SEWAGE DISPOSAL SYSTEM

HOWARD COUNTY HEALTH DEPARTMENT

ADDRESS 11954 Simpson Road, Clarksville, MD 21029

REPAIR - PURPOSE - SEPTIC SYSTEM HAS FAILED.

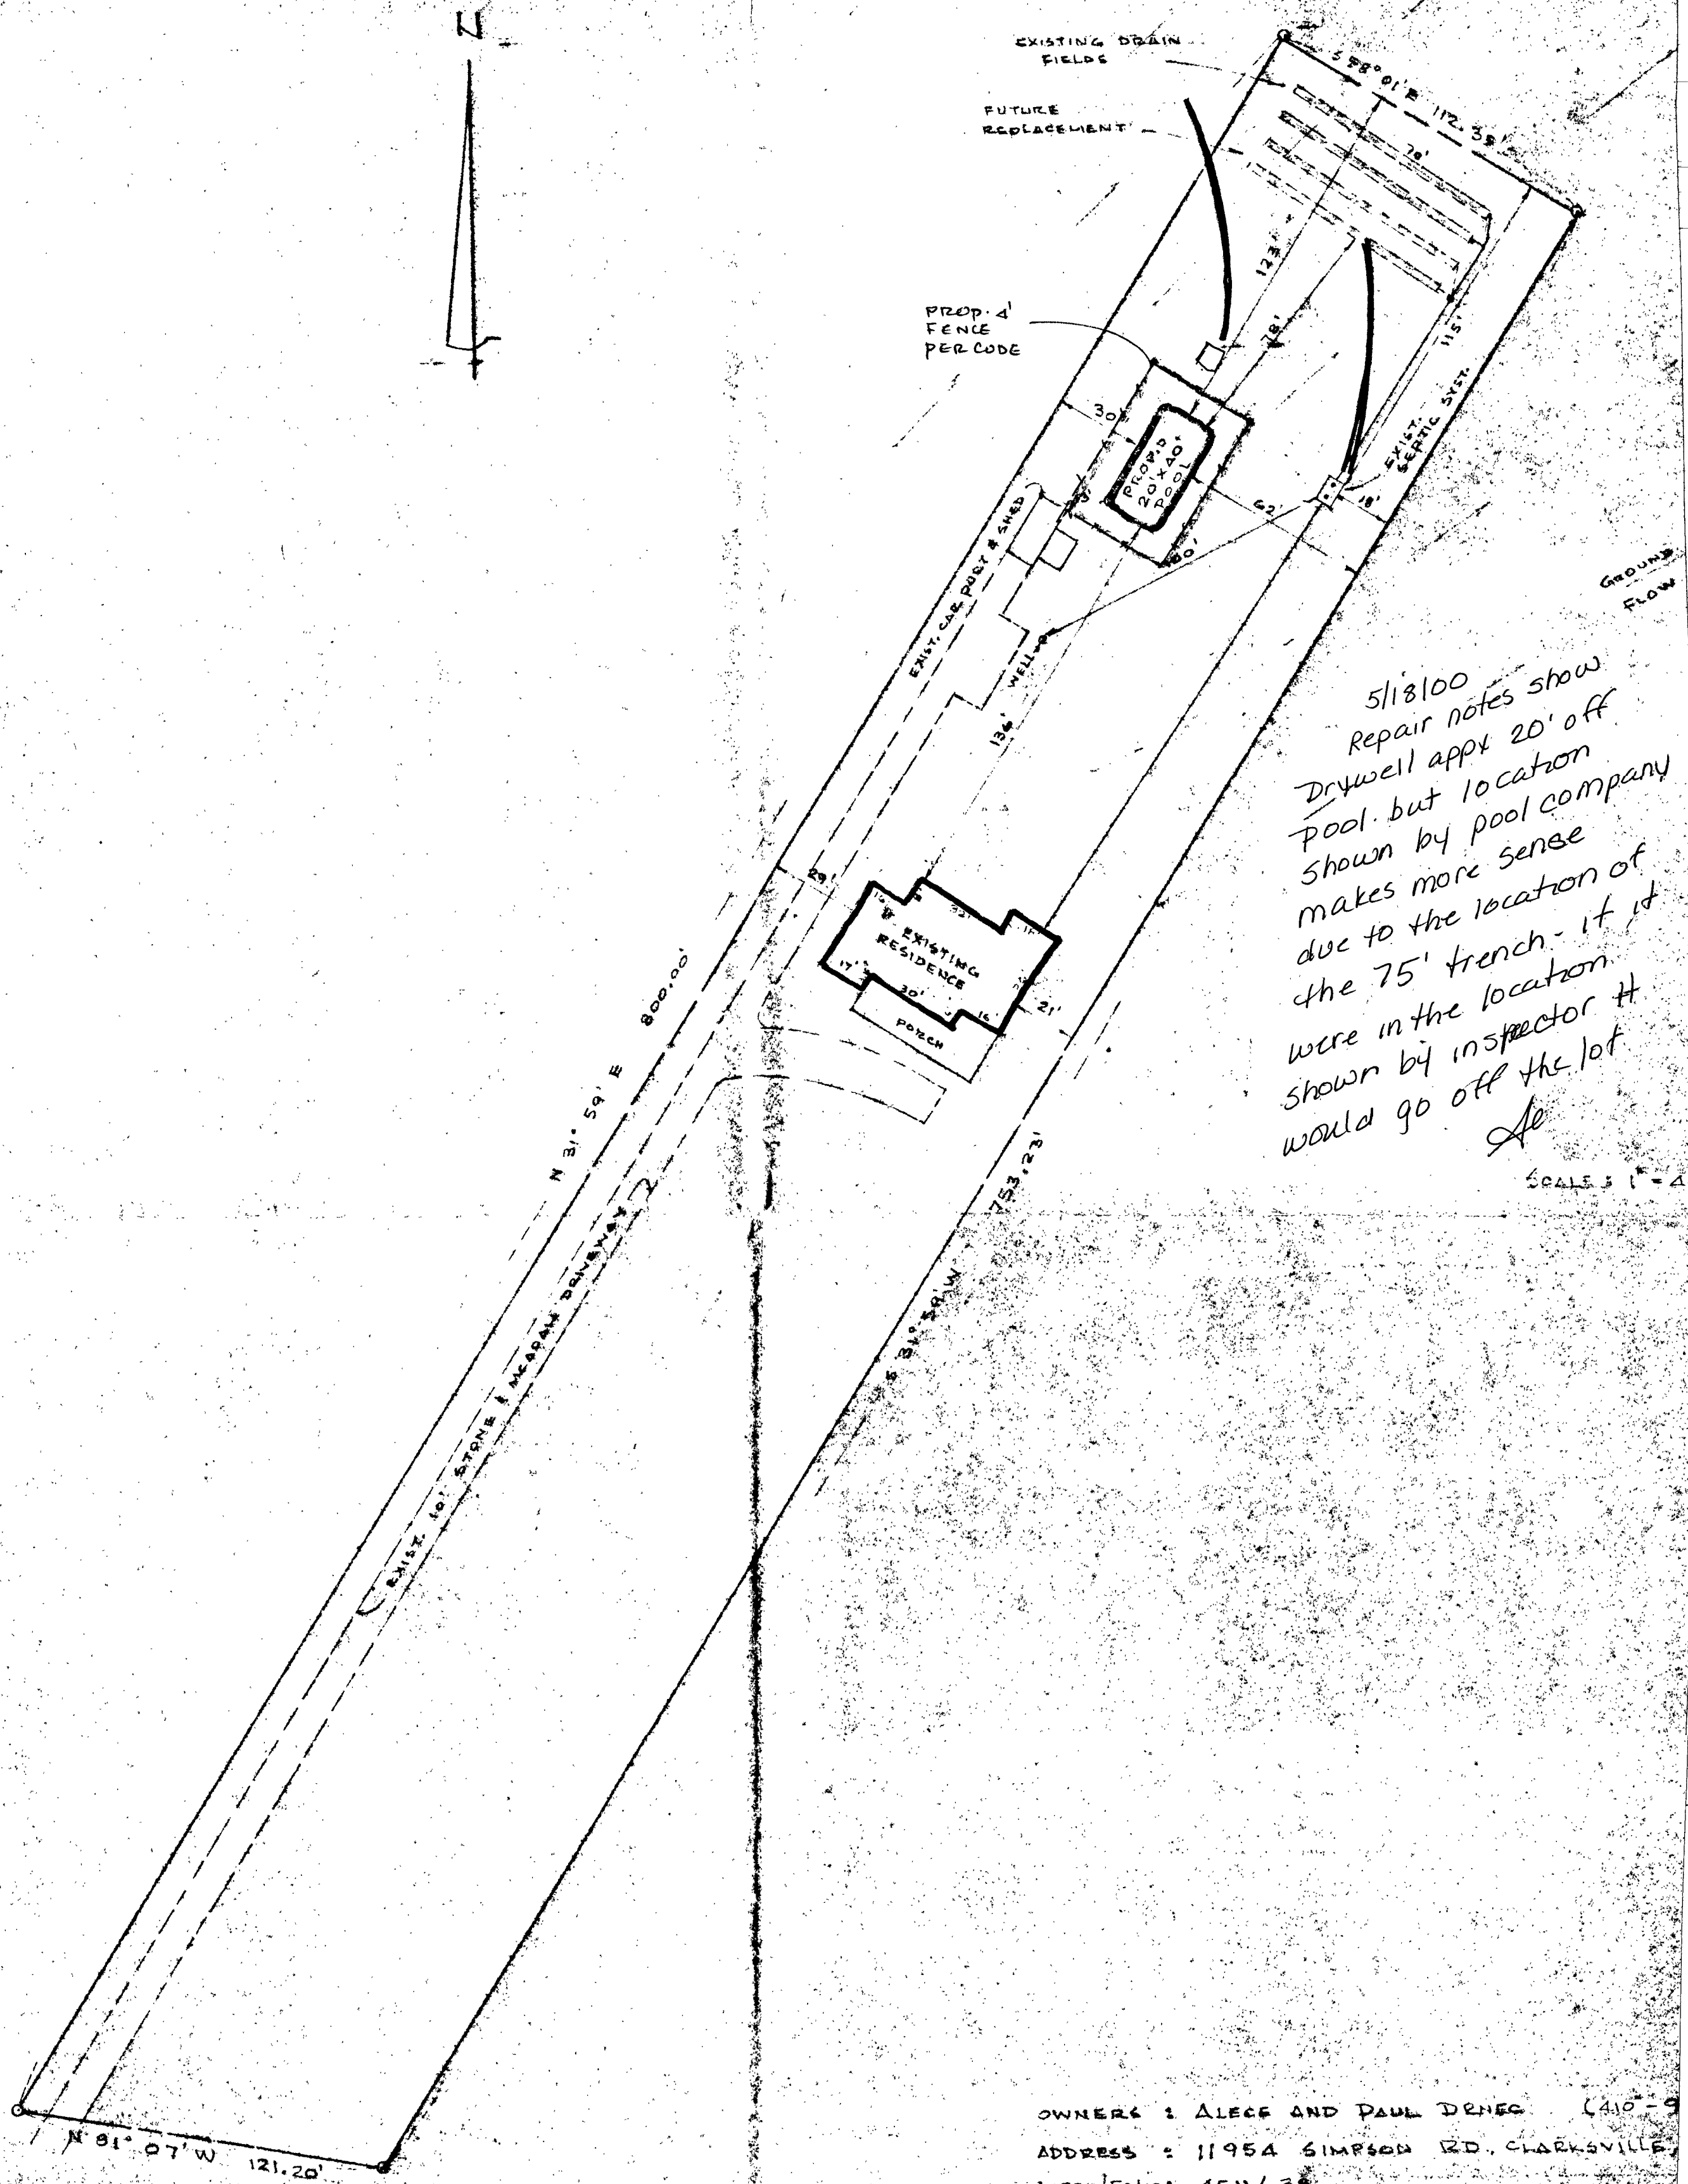
REMARKS: 8/31/95 A.M. OK to begin trench at site of perc hole. DKS

8/31/95 P.M. OK to store trench and continue. DKS

9/1/95 OK to cover all work final Au

5/18/00
 Repair notes show
 Drywell approx 20' off
 Pool but location
 shown by pool company
 makes more sense
 due to the location of
 the 75' trench - if it
 were in the location
 shown by inspector it
 would go off the lot
 A

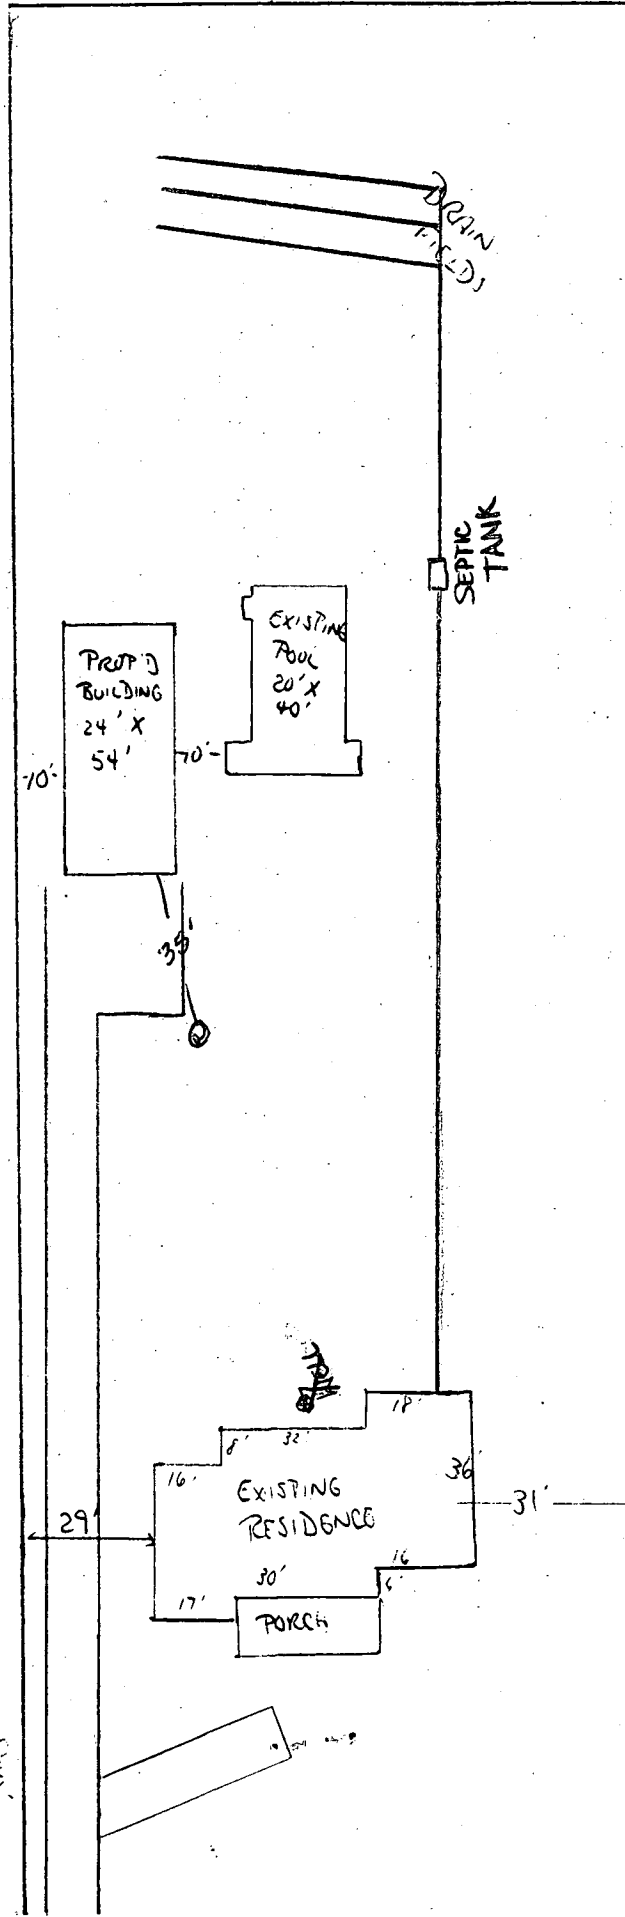
2/8/08
shown garage/storage
building will have
no impact on ex well
or septic. OK to proceed.
